County of Loudoun
Department of Planning
MEMORANDUM

SUBJECT: SPEX 2008-0042, The Compass School – Ashbrook – 2nd Referral

SUBJECT: SPEX 2008-0042, The Compass School - Ashbrook

Proposed Plat

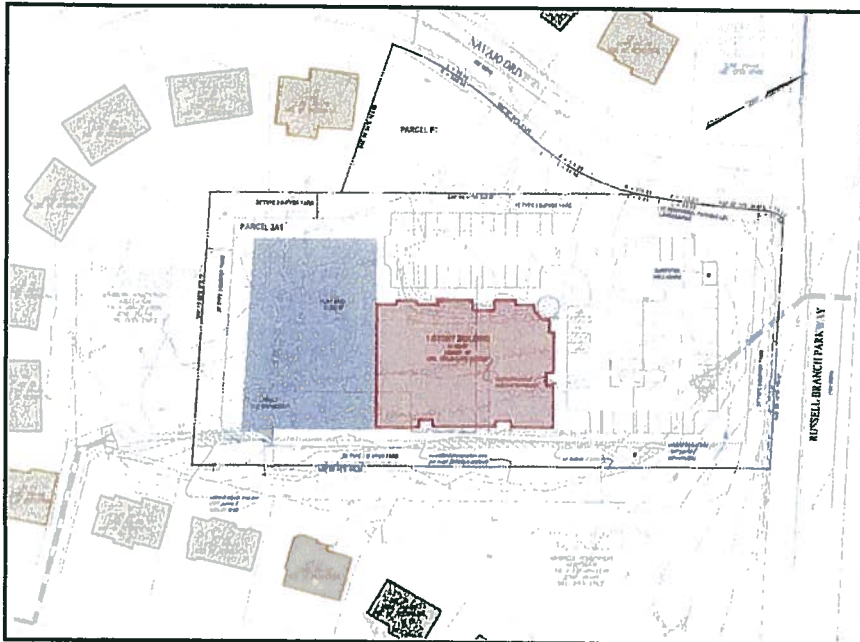
The applicant has placed the building in the central portion of the site, with the play area toward the rear and the majority of parking adjacent to Russell Branch Parkway and Navajo Drive. The applicant has also submitted a building illustrative, depicting a single-story building. The plat specifies a maximum proposed height of 40 feet.

Staff recommends that the applicant commit to a building placement and design that addresses the issues raised in the Revised General Plan and Retail Plan to include:

- **Rooflines, materials, window arrangement, sign location, and architectural details compatible with the surrounding buildings;**
- **Usable outdoor spaces and amenities for employees and children, such as shaded benches and picnic tables;**
- **Building recesses, off-sets, angular forms, or other features;**
- **Distinctive roof forms; and**
- **Weather protection over the front walkway.**
